ISO New England Operating Procedure No. 18 Metering and Telemetry Criteria (OP-18)

Revision **20**, Effective Date: **draft**

Example Test Scheme for a DC Meter with Voltage Inputs.**Figure 9-1****Example Pulse Target Worksheet**

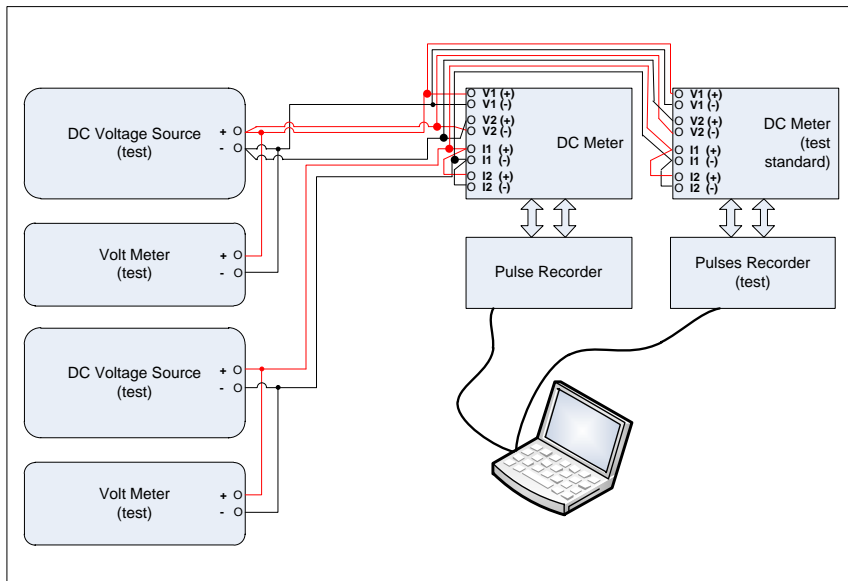
2. HVDC Wh meters - dc Wh metering equipment utilizing voltage inputs for current and voltage sensing shall conform to the following requirements. See Figure 9-1.

[In addition](#), the start and stop time as well as the accumulated energy during the test period [shall](#) be noted for the in-service meter.
